**Resource Consent Application LUC 2017-48 & SUB 2017-26, 143 to 193 Moray Place, Dunedin**

Submissions on the additional information provided by the Applicant as per Minute issued 3 August 2017

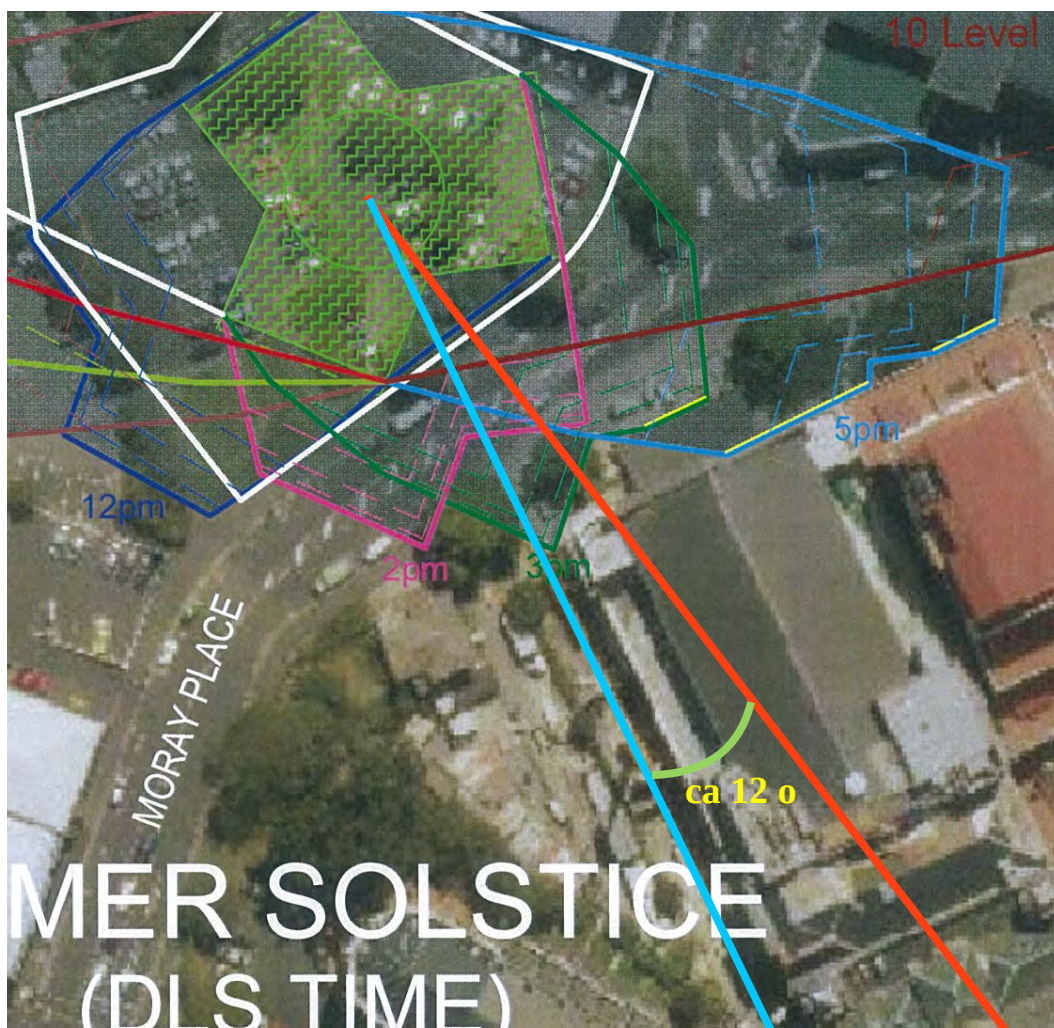
Aligning these steps to Dunedin's most significant view-shaft along Harrop Street to the Octagon and First Church's spire, would be a grand way of recognising the Dunedin streetscape.

Unfortunately the flight of steps is not aligned to Harrop st - it's aligned about 12 degrees east.

This means that the “view shaft” does not offer “a strong visual and physical connection to the main public entrance of the proposed Hotel Development” any more than the hotel development provides a strong visual and physical connection or recognition of this iconic streetscape. Its lack of connection arises because the building was clearly designed without any knowledge or understanding of the lay-out of this part of Dunedin and has been plonked onto the site without making any connection to the streetscape's values. None of its many flanks faces the street or runs parallel to any of the facades of nearby buildings.

Figure 5: Of Those in the Sun, the Proportion Sitting as a Function of Temperature (also for those in the shade)

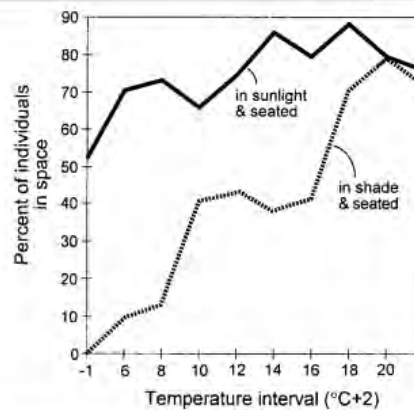
- 34 Recognising that when it is cold, people tend not to linger and move to keep warm, the researchers note that *"even at quite low temperatures, more than half the individuals are seated in sunlight"*.<sup>8</sup> This is seen below in Figure 5.

### **LOADING BAY ACCESS**

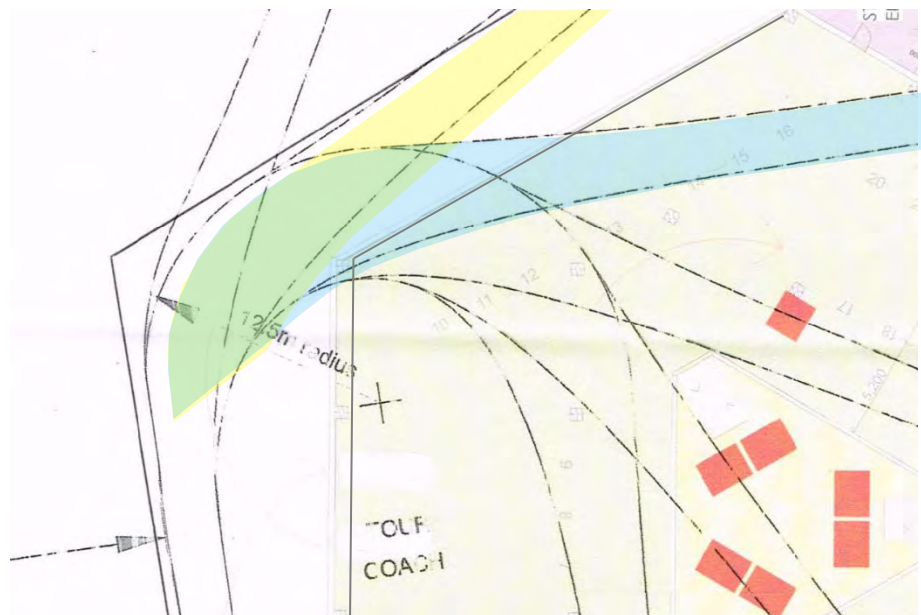
- 11 The revised levels associated with the perimeter roadway also address the matter which I previously raised of service vehicles turning into the loading bay from a steep gradient.

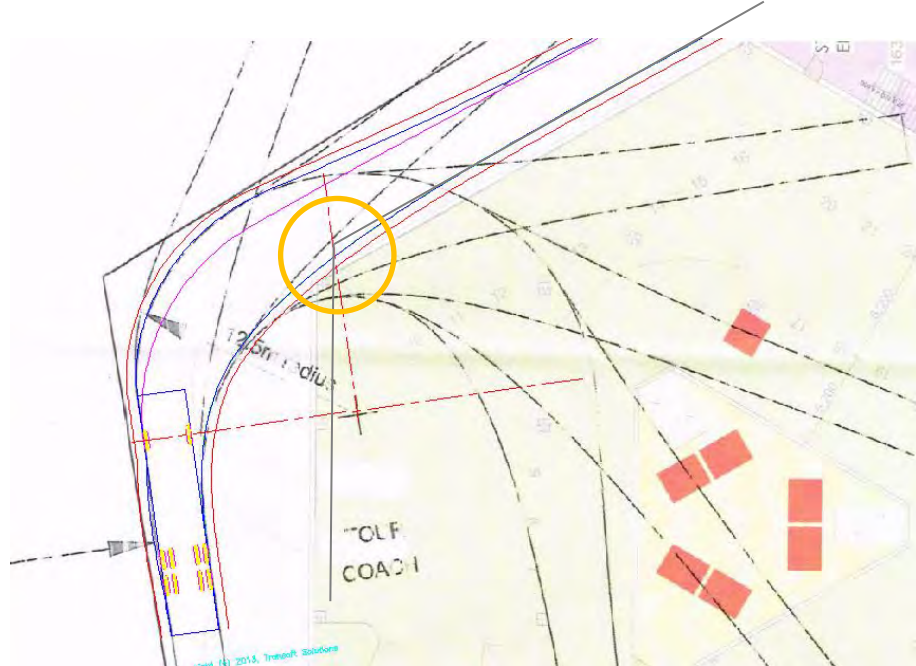
- 15 I have highlighted two swept paths. One (yellow) is the swept path of the coach making a 60-degree turn. This shows that the coach would not strike the building at the corner that I previously identified was of

concern – however it also shows that the coach would have to turn through more than 60 degrees to avoid over-running the boundary.

- 16 The second swept path is shown in blue. This is a 90-degree turn, and shows that the coach would strike the building at the corner. However it also shows that if a coach was to turn through 90 degrees then it would also drive through the wall of the building which clearly would not occur. In practice, the vehicle would turn through less than 90 degrees.
- 17 In fact, the angle of turn required to be made by the coach is in the order of 70 degrees, for which there is no standard swept path, and which is not shown by Mr Facey. I have therefore used the AutoTurn software package to generate a swept path, using the same 'design coach' that Mr Facey has used. In the first instance, I have overlaid a coach turning at 60 and 90 degrees, to ensure full alignment with that used by Mr Facey.

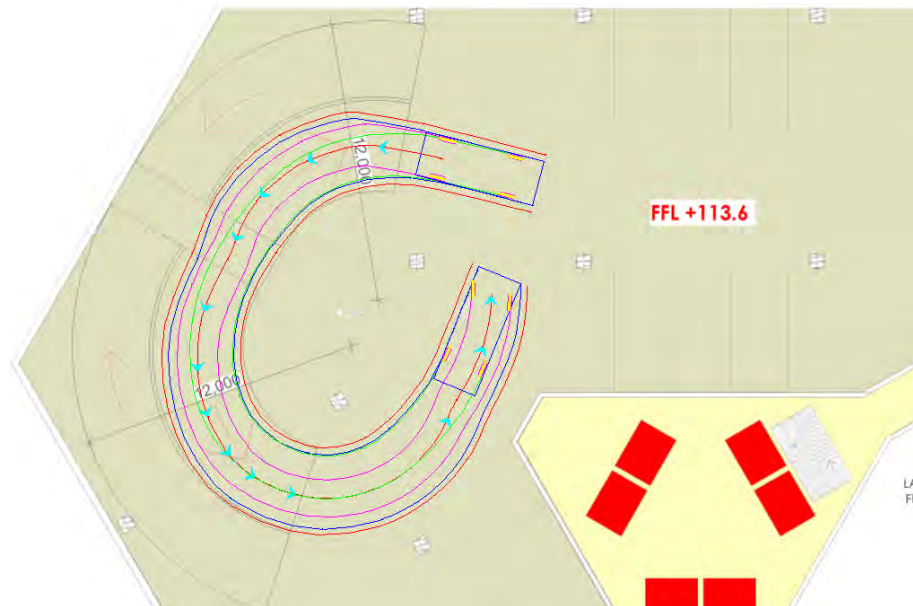
- 20 The graphic shows that the bodywork on the inside of the curve is 0.4m *within* the required clearance – that is, the vehicle body is just 0.1m from the side of the building. For comparison, this is less than the width required for a wing mirror.
- 21 In my experience, it is highly unusual to accept a layout which has such a degree of intrusion into the required clearance. Minor incursions are sometimes acceptable, but this represents a reduction of 40% in the total required clearances and so in my view the additional information presented confirms that there a very high potential for vehicle strike.
- 22 As I noted in my Evidence in Chief, if coaches cannot use the perimeter road then drop-off and pick-up activity will occur on the frontage roads instead.
